BELLEFONTE COMBINED LICENSE APPLICATION – RESPONSE TO REQUEST FOR
ADDITIONAL INFORMATION – QUALITY ASSURANCE

Reference: Letter from Ravindra G. Joshi (NRC) to Andrea L. Sterdis (TVA), Request for
Additional Information Letter No. 013 Related to SRP Section 17.5 for the
Bellefonte Units 3 and 4 Combined License Application, dated May 12, 2008

Subject: Quality Assurance

TVA QAPD
 FUNCTIONAL ORGANIZATION

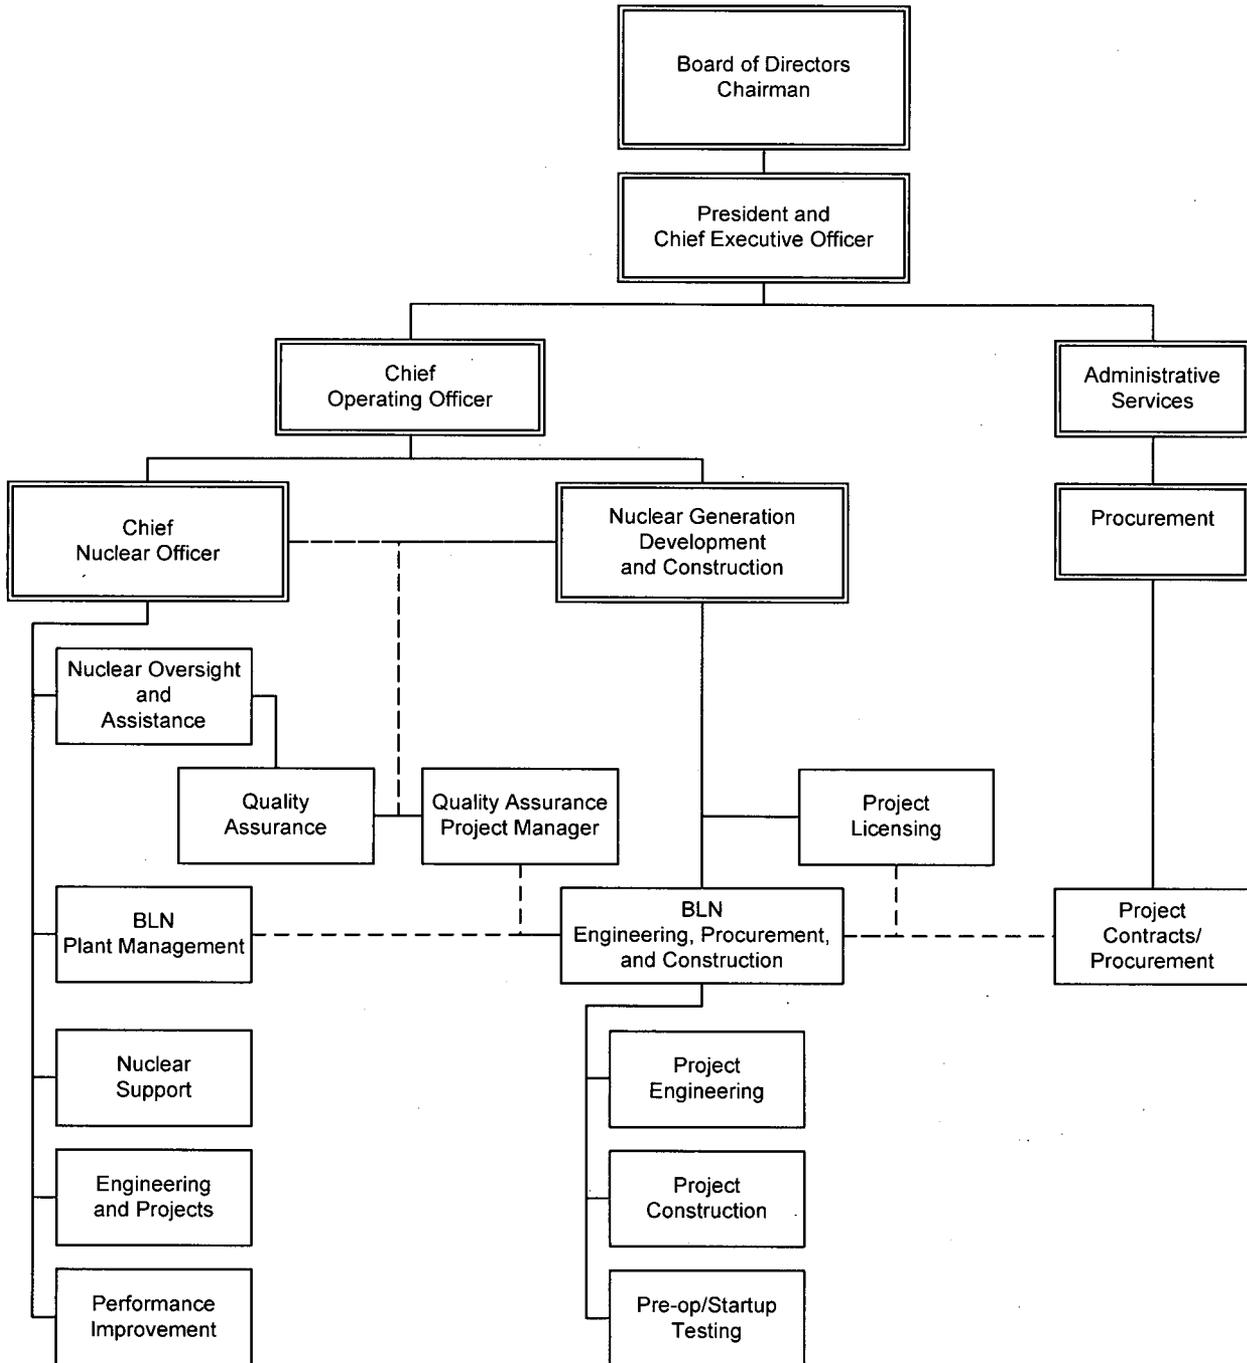
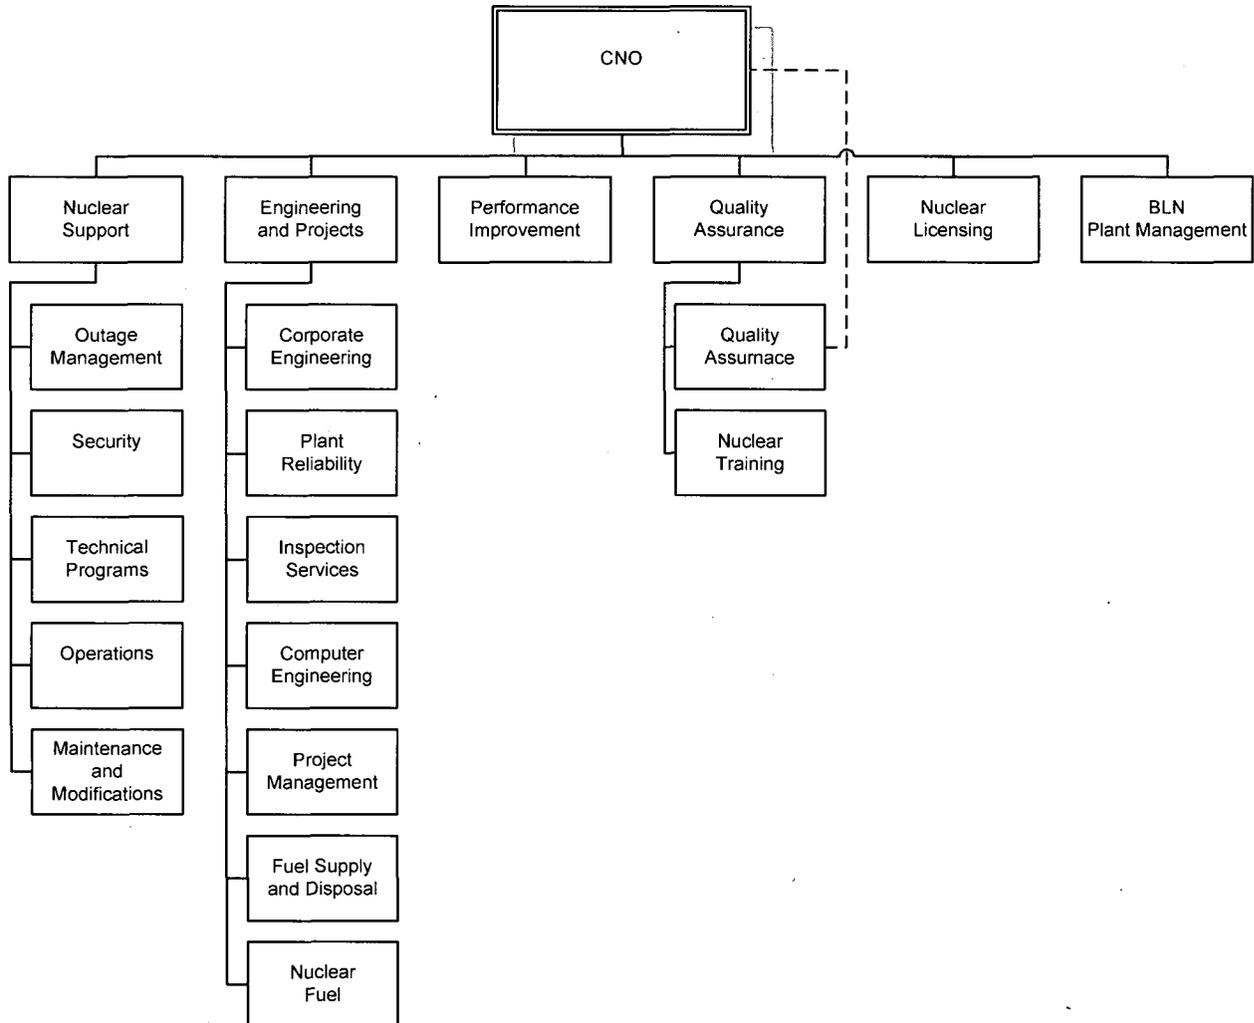
Part II, QAPD Details, Section 1, Organization, of the Bellefonte QAPD states, in part, that the TVA Nuclear Power Group and the Nuclear Generation Development and Construction (NGDC) organization are described in the QAPD. Appendix B to 10 CFR Part 50 states, in part, that every applicant for a combined license under 10 CFR part 52 is required by the provisions of 10 CFR 52.79 to include in its FSAR a description of the quality assurance applied to the design, and to be applied to the fabrication, construction, and testing of SSCs of the facility and to the managerial and administrative controls to be used to assure safe operation. Please provide the QAPD's description of the managerial organization for operations, including the functions of the following positions that are referred to in Section 1 and Section 2.7, Independent Review: Chief Operating Officer, Executive Vice President, Site Vice President, Site Director, and Plant Manager. The NRC staff notes that TVA Nuclear Quality Assurance (NQA) Plan (TVA-NQA-PLN89-A) revision 18 contains adequate detail of the operations organization for the existing TVA fleet. Please provide similar information in the Bellefonte QAPD to address the applicable requirements of Appendix B.

The QAPD will be revised to add a high level functional organization chart as QAPD APPENDIX A and to provide more details in the operations area. QAPD Part II, Section 1 will be revised to provide additional details of the generic managerial organization for operations and to include the Chief Operating Officer, BLN Plant Management, Nuclear Oversight and Assistance, and Nuclear Licensing as shown below in the Application Revision section.

c. Insert the following functional organization charts as APPENDIX A:
